## Service Bulletin No. 54

TO: Service Managers  
DATE: March 23, 1994  
RE: Jurassic Park, Last Action Hero & Tales from the Crypt  
**FLIPPER / END OF STROKE FAILURES**

DATA EAST PINBALL, INC.  
 Solid State 3-Flipper Board  
 520-5033-03 Rev. C  
 compatible to  
 520-5076-00 Rev. A  
 after modifications

Fig. 1

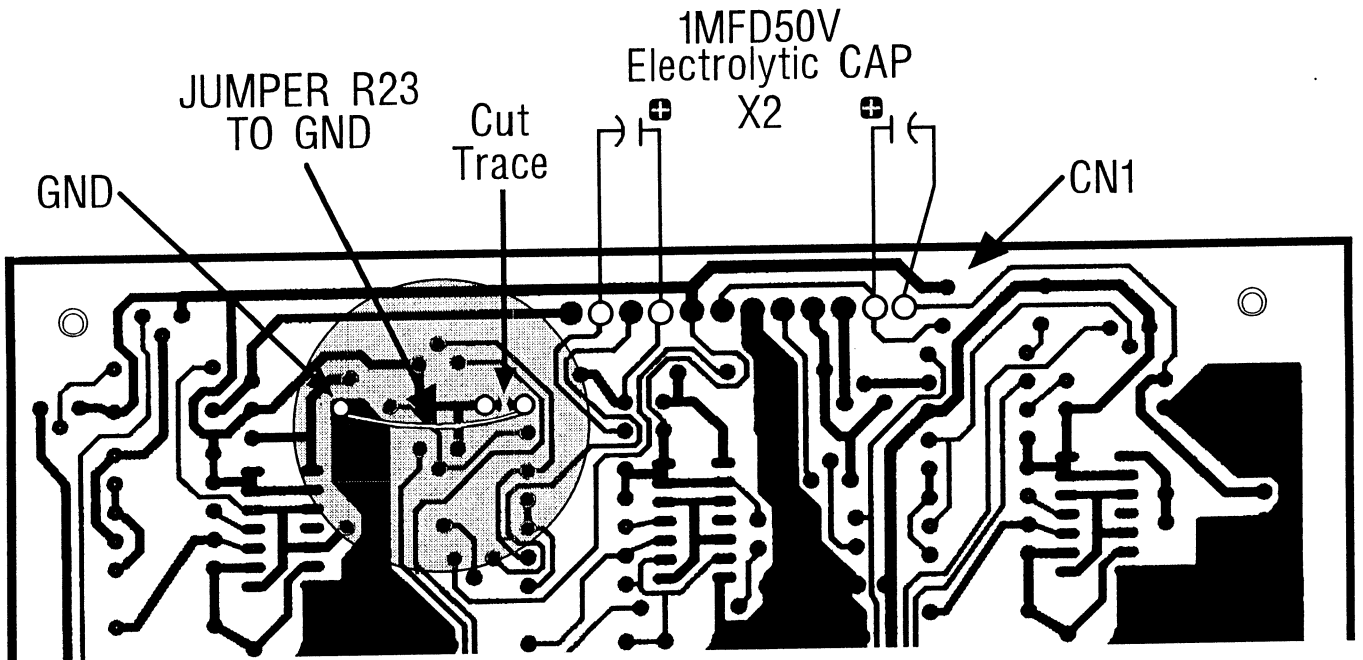
**Problem:** End of stroke switches are failing. This is due to the switch blade cracking. The cracks are known to be occurring between the baka-lite wafers, which in turn isolate the switch blades from each other; therefore, not making the switch failure visible to the eye. The failure can be diagnosed by attaching a jumper wire across the switch lugs and retesting the flippers under power.

- Step 1
- A) Remove flipper bd. # 520-5033-03 from game cabinet.
  - B) Cut the trace (bottom side) that connects R23 & R25. (See Fig. 1)
  - C) Add jumper (bottom side) from cut side of R23 Ground. (See Fig. 1)

- Step 2
- A) Right Flipper: Take the 1MFD 50V Capacitors and attach 1 cap. to CN1, {+} (positive) side to Pin 2 and {-} (negative) side to Pin 1. (See Fig. 1)

- B) Left Flipper: Attach the second cap. to CN1, {+} side to Pin 9 and {-} side to Pin 11. (See Fig. 1).
- Step 3
- A) Add resistors and diodes to the topside. (See Fig. 2)

Fig. 2

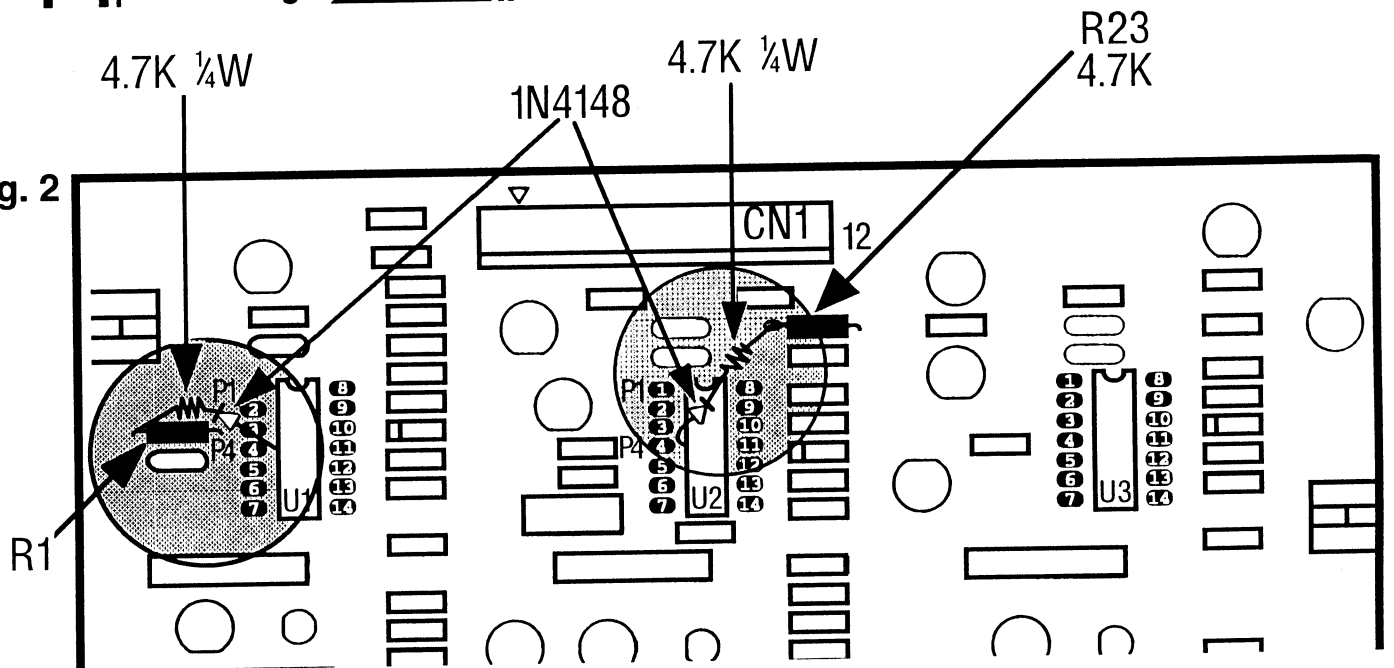
**Solution 3:** *Modify* existing Flipper Board, part #520-5033-03. This update to the old board modifies the circuitry which prevents the failure of the flippers if the End of Stroke Switch fails.

- B) Attach by twisting and soldering one lead of each resistor to the cathode (banded side) of the diode. Do this to both diodes.
  - C) Attach the resistor / diode set. Cut and solder the anode lead (non banded side) to IC location U1 Pin 4, solder the other end of the resistor / diode to location R1 (See Fig. 2 Left shaded area). This takes care of the right flipper.

- D) Attach the 2nd resistor / diode set. Cut and solder the anode lead (non banded side) to IC location U2 Pin 4, solder the other end of the resistor /diode to location R23 (See Fig. 2 Right shaded area). This takes care of the left flipper.
